Re: Indian Point Unit No. 2  
Docket No. 50-247  
NL-05-093

**Subject:** Reply to Supplemental RAI regarding Fuel Storage Building Single-Failure-Proof Gantry Crane

**REPLY TO NRC SUPPLEMENTAL REQUEST FOR ADDITIONAL  
INFORMATION REGARDING PROPOSED LICENSE AMENDMENT  
REQUEST FOR NEW FUEL STORAGE BUILDING GANTRY CRANE  
AT INDIAN POINT 2**

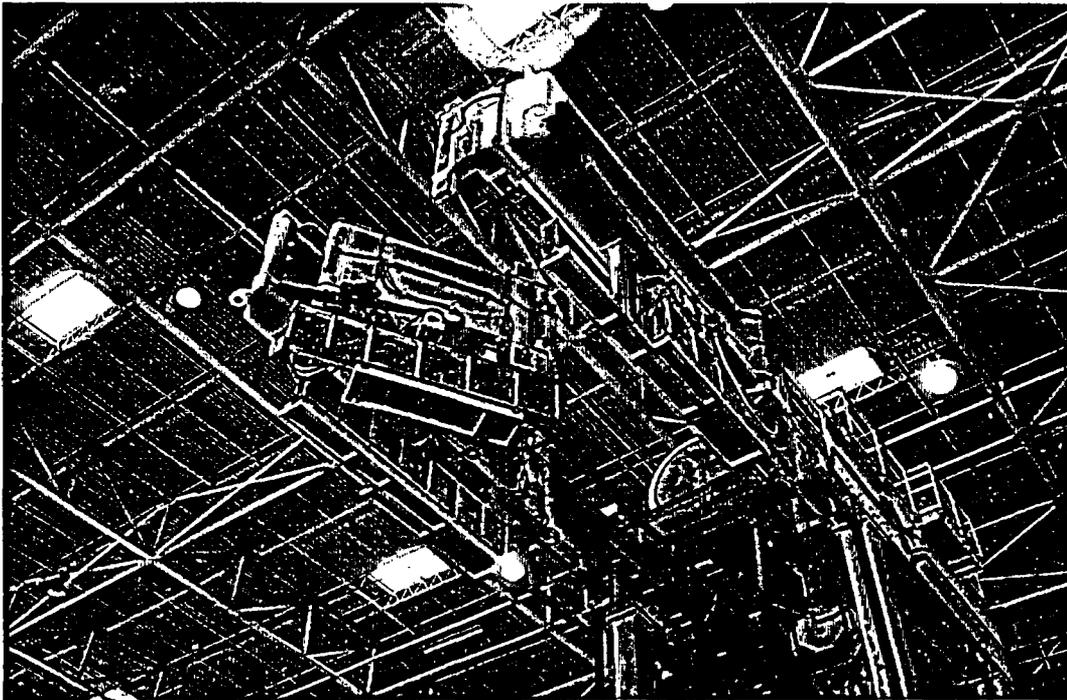
Describe, in sufficient detail, the logic that will prevent the occurrence of the following scenarios, and whether these protection schemes can be overridden by the operators:

- (a) Movement of the trolley north towards the pool when the arms have not yet been extended and pinned in place;
- (b) Movement of the trolley when the main transfer hoist is at an operating elevation that does not allow the HI-TRAC to clear the south wall of the spent fuel pit; and
- (c) Movement of the trolley towards the pool when the turnbuckles have not been attached to the crane tie down points.

There are multiple safety interlocks that prevent improper north motion of the trolley toward the fuel pool. The following interlocks described below need to be satisfied in order to allow trolley motion north towards the fuel pool. These design features in conjunction with detailed procedures and task specific training will ensure the movement of the trolley will occur at the appropriate times in the procedure when the interlocks are satisfied.

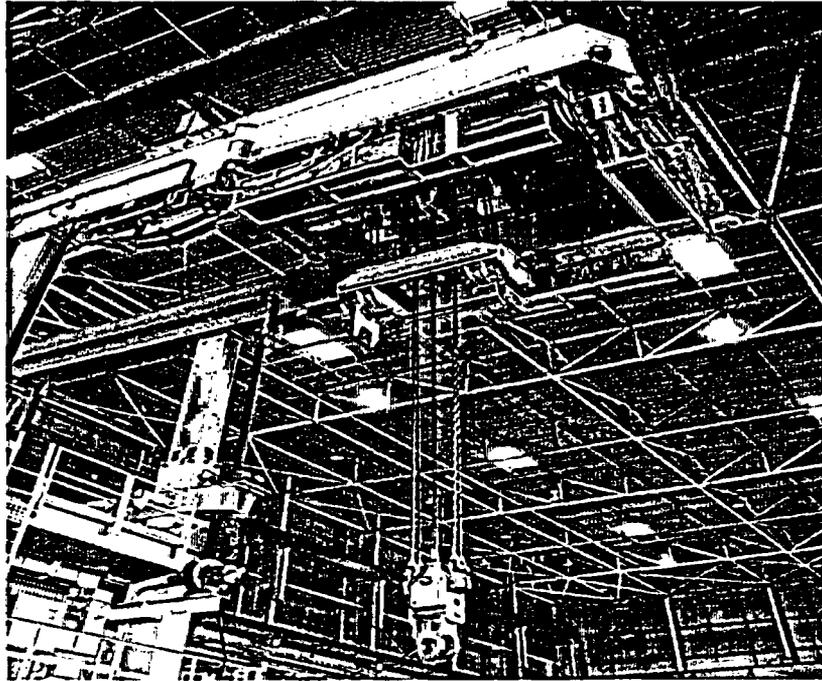
- b. **Scenario –** Movement of the trolley when the main transfer hoist is at an operating elevation that does not allow the HI-TRAC to clear the south wall of the spent fuel pit.

**Protection System –** The main hoist and canister hoist must be raised to their respective geared upper limit positions before the trolley is allowed to move north or south over the pool wall. These hard-wired interlocks prevent the trolley motion if not satisfied. If these interlocks are not satisfied, a primary cantilever limit switch will stop the trolley

motion prior to movement onto the cantilever. If the trolley moves beyond the primary cantilever switch, a secondary cantilever limit switch will remove 480v AC power to the trolley motor controller and brake. Removal of power to the brake control sets the brakes.

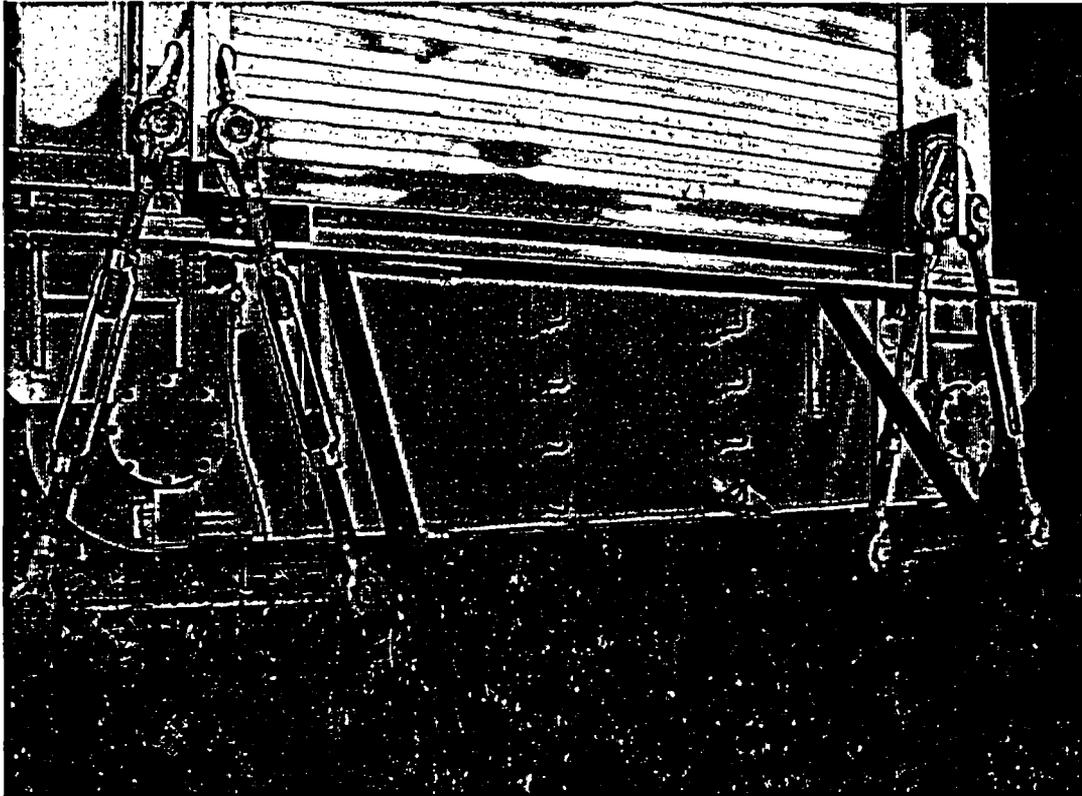
- c. Scenario – Movement of the trolley towards the pool when the turnbuckles have not been attached to the crane tie down points.

Protection system – Four (4) turnbuckles are attached on the south truck tie down points. See picture below. Two (2) similar turnbuckles are attached on the north truck tie down points. When all six (6) turnbuckles are mechanically secure, six (6) individual tie down proximity switches are actuated. These hard-wired interlocks prevent trolley motion if not satisfied. If these interlocks are not satisfied, a primary cantilever limit switch will stop trolley motion prior to movement onto the cantilever. If the trolley moves beyond the primary cantilever switch, a secondary cantilever limit switch will remove 480v AC power to the trolley motor controller and brake. Removal of power to the brake control sets the brakes.
